Bell Helicopter **TEXTRON**

INFORMATION LETTER 214ST-01-15

SUBJECT: Combining Gearbox Assembly Output Adapter Installation

VIEW LOOKING DOWN AT SECTION
THRU CENTER OF OUTPUT ADAPTER

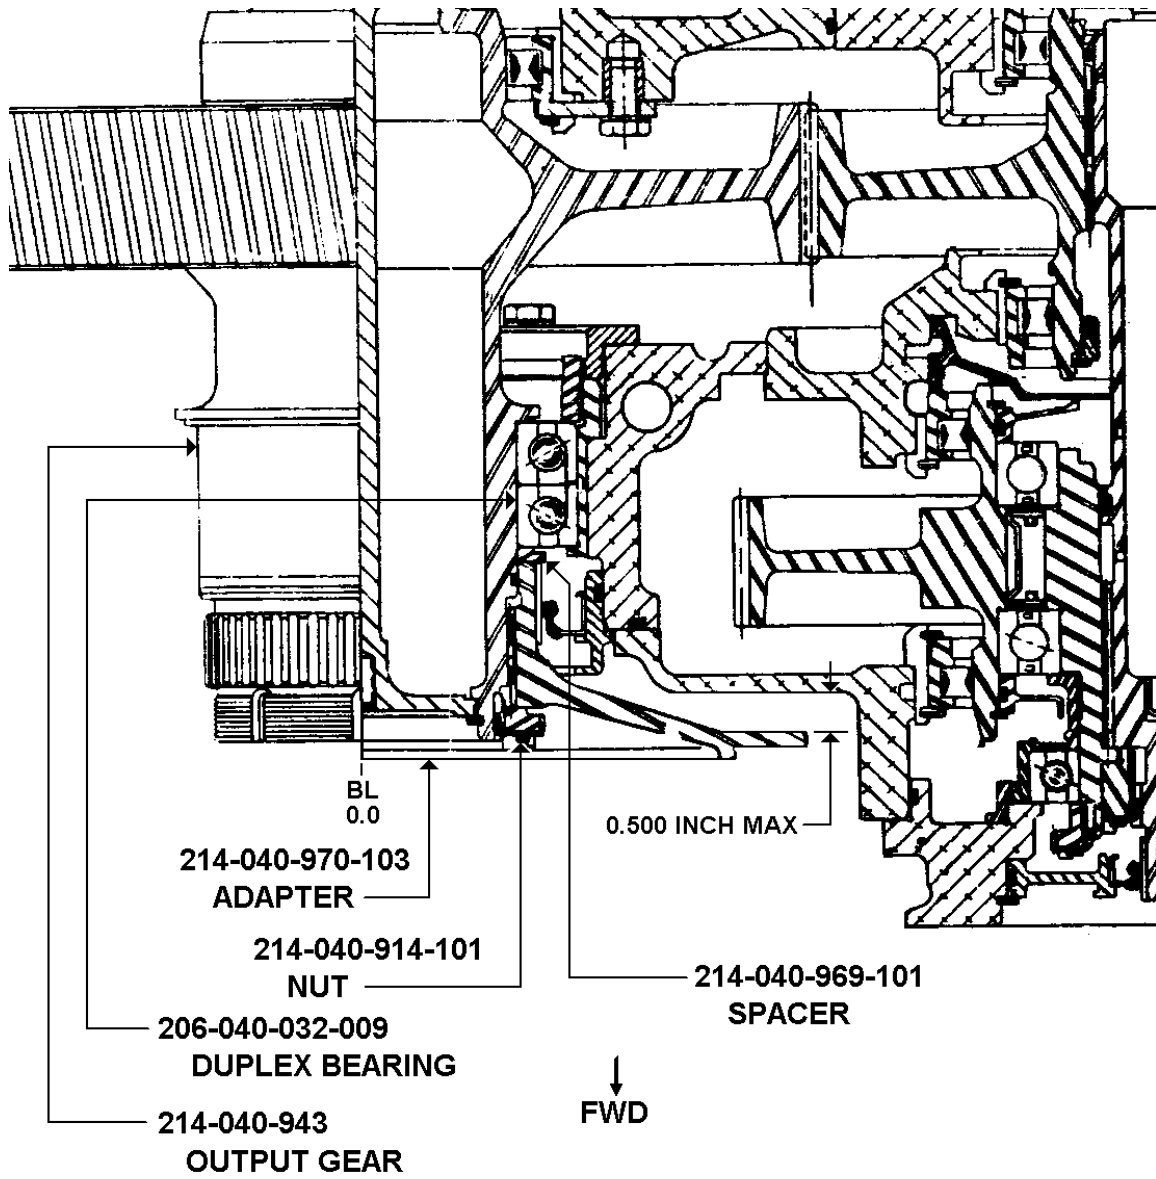
The 214ST combining gearbox output adapter, P/N 214-040-970-103, is installed with a single P/N 214-040-969-101 spacer between the aft end of the adapter and the inner race of the P/N 206-040-032-009 duplex bearing (see illustration on page 2).

BHT has received several reports of a second P/N 214-040-969-101 spacer installed behind the output adapter in AH-1W combining gearboxes that have been returned for overhaul to U.S. government facilities. While we have no similar reports from the 214ST fleet, this information letter is issued to advise operators of these reports.

Installation of a second spacer can result in improper engagement of the P/N 214-040-914-101 adapter retaining nut, could cause premature wear of the adapter splines, and possibly create a leak path due to improper sealing with the output gear o-ring. Operators may make a simple dimensional check as noted on the illustration. Any dimension over that noted would be cause for further investigation to determine if a second spacer has been installed.
